Access Compliance Report

Public Rights-of-Way (Curb Ramps)

Intersection ID: 19611		Main Street: FOXCROFT_RD		Cross Street: WARBURTON_RD		Location: NE			
ADA ID: B1949738EDBF		Ramp Type: Directional1		Initial Pass/Fail: Fail		Overall Compliance: No		Severity Score: 10	
Codes/Mitigation Info/Possible Solution				Field Measurements/Component Compliance

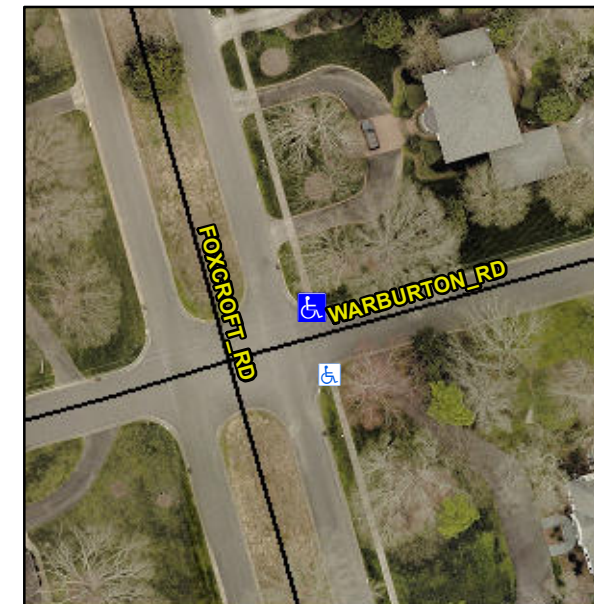
Surveyor Notes:

ASP LIP 1.0"

PROW/ADA:

R304.5.1, R304.5.3

Possible Solutions:

Remove & Replace Entire Ramp.
